**Briargate Bridge at Sand Creek  
Design Report  
Sand Creek Drainageway

El Paso County, Colorado**

CDR-21-013

HEC-RAS Plan: Proposed Floodway River: Sand Creek Reach: Briargate Only Profile: 100yr

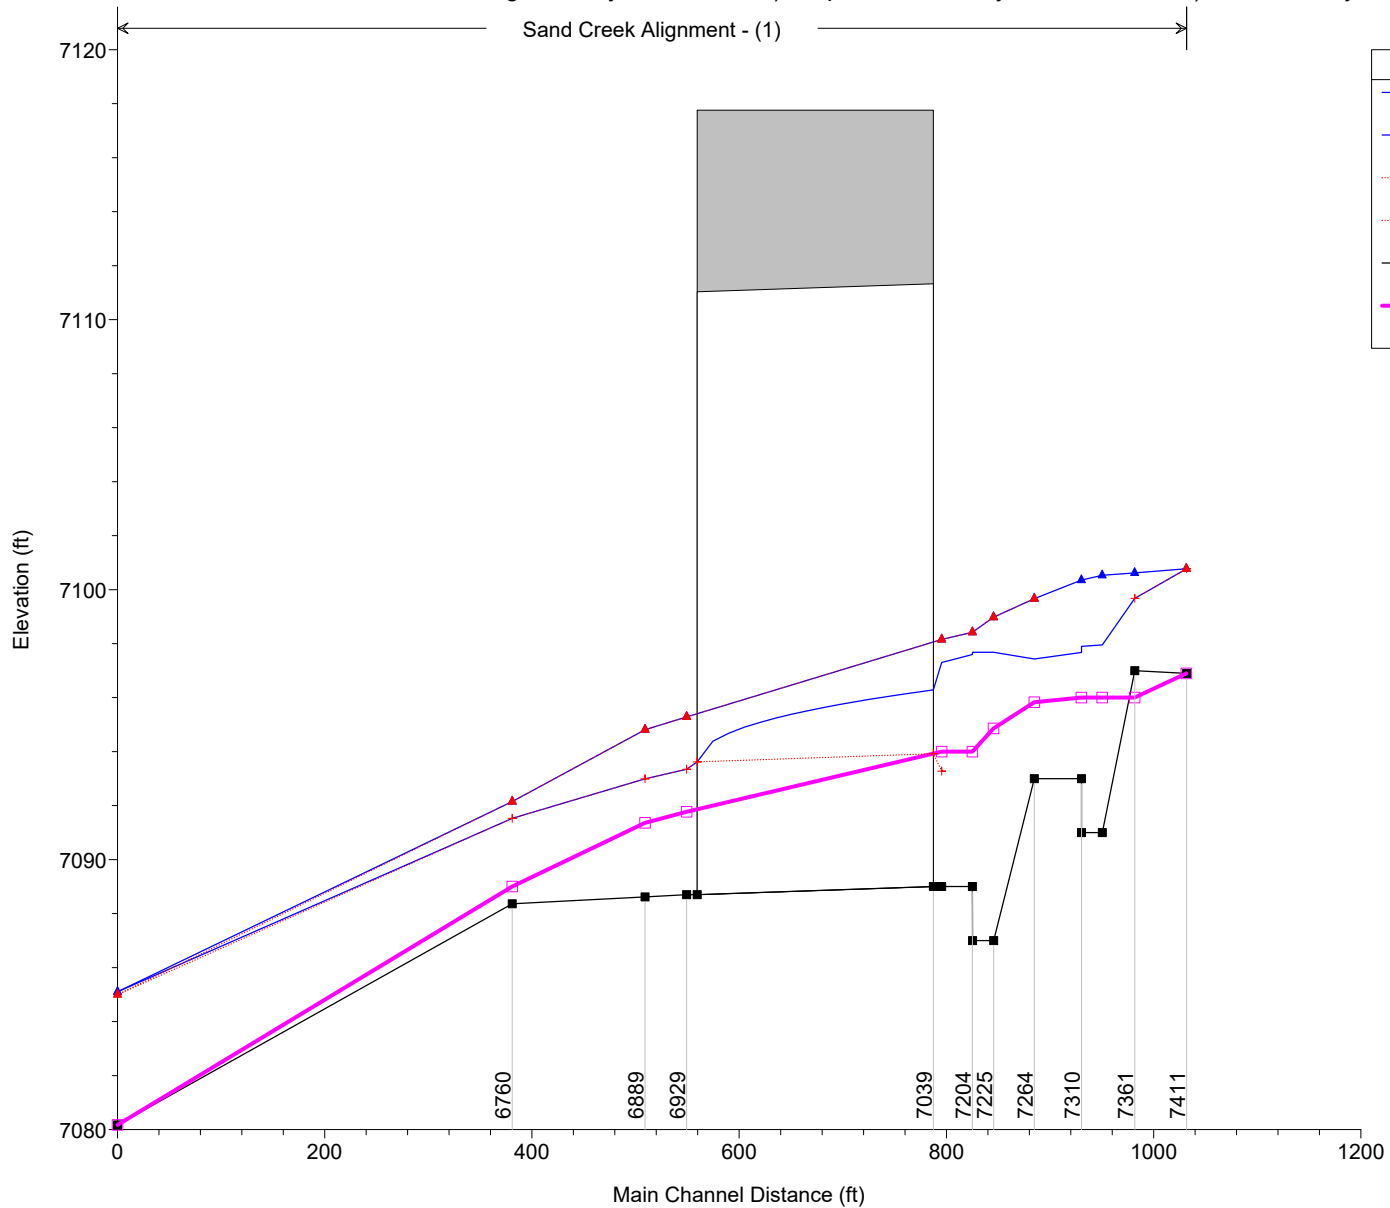
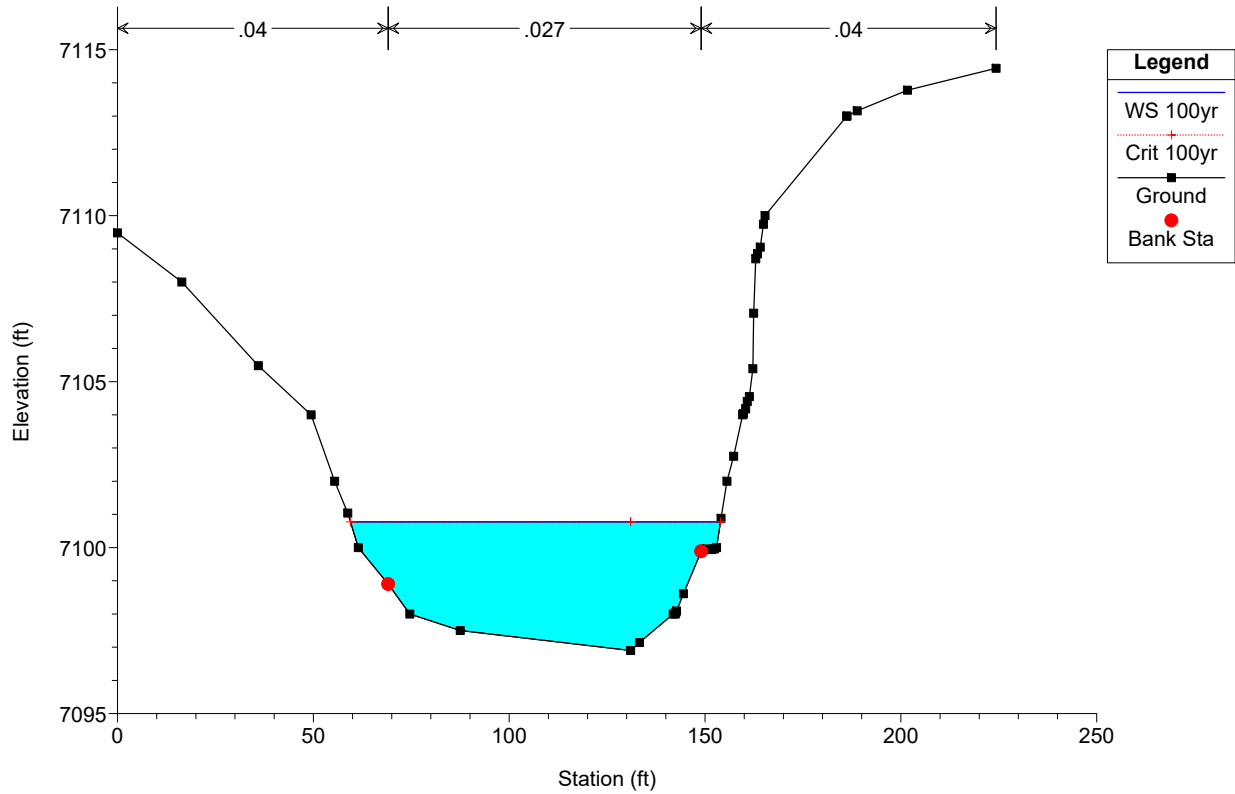
Please run with the DP-69 flows also (1870 cfs) and provide that table also
